# Safety Recall

## Code: 20Y6

**REVISION**

<b>Subject</b>	<b>Suction Pump</b>
<b>Release Date</b>	December 21, 2016
<b>Revision Summary</b>	<b>Certain work instruction steps have been modified to help technicians avoid consequential damage during this repair.</b>
<b>Affected Vehicles</b>	<b>U.S.A. &amp; CANADA: 2015-2016 MY Volkswagen Golf, GTI &amp; Golf SportWagen</b> <i>Check Campaigns/Actions screen in Elsa on the day of repair to verify that a VIN qualifies for repair under this action. Elsa is the <u>only</u> valid campaign inquiry &amp; verification source.</i> <ul style="list-style-type: none"><li>✓ Campaign status must show "open."</li><li>✓ If Elsa shows other open action(s), inform your customer so that the work can also be completed at the same time the vehicle is in the workshop for this campaign.</li></ul>
<b>Problem Description</b>	The suction pump inside the fuel tank designed to purge fuel from the evaporative emissions (EVAP) system may have been damaged during assembly. This could cause fuel to flow directly into the EVAP system which could, over time, accumulate and cause a leak through the charcoal canister filter element. Leaking fuel, in the presence of an

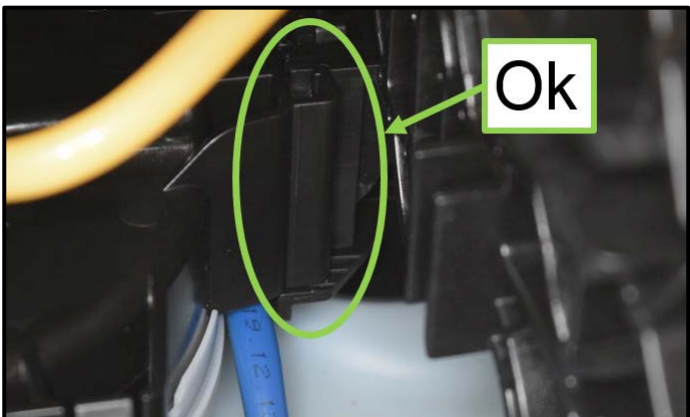
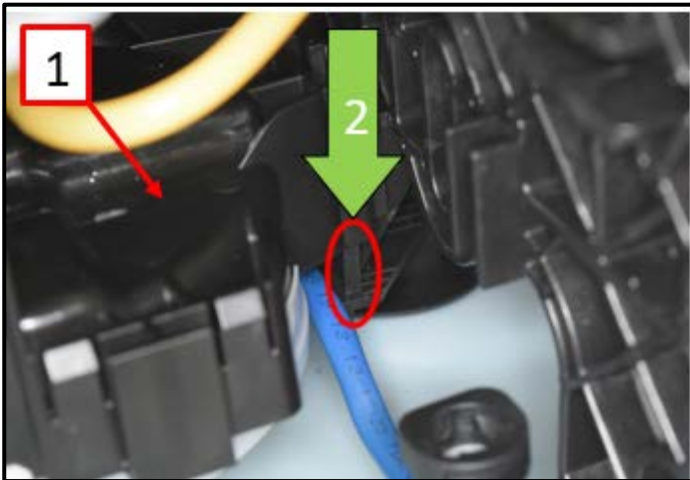
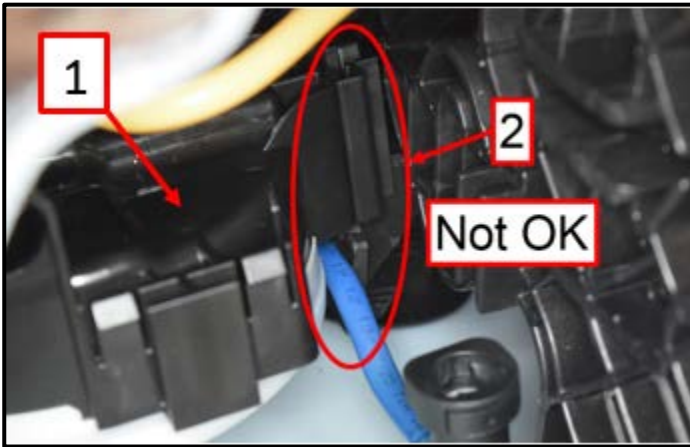
- Take care that the Liquid-Vapor Separator Assembly <1> does not come off of its attachment bracket when removing the Suction Jet Pump.

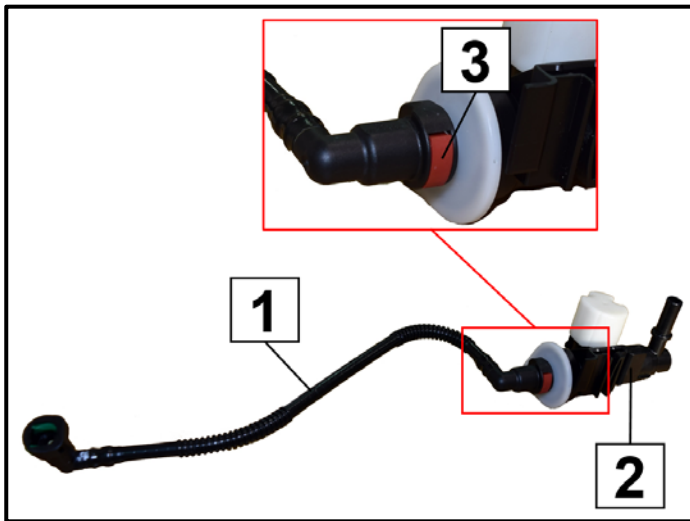
- If the Liquid-Vapor Separator <1> comes loose and is not reinstalled onto the mounting bracket, a customer comeback for rattling in the fuel tank, or EVAP system faults may occur.
- The Liquid-Vapor Separator <1> can be reinstalled onto its mounting bracket <2>.
- Replacement of the fuel tank for the Liquid-Vapor Separator dislodging from the mounting bracket are not covered under this campaign.

- If the Liquid-Vapor Separator Assembly <1> comes off the mounting bracket during suction pump removal:
  - Snap the Liquid-Vapor Separator <1> back into place by realigning it with the mounting bracket.
  - Push down on the Liquid-Vapor Separator to reengage the clip <2>.
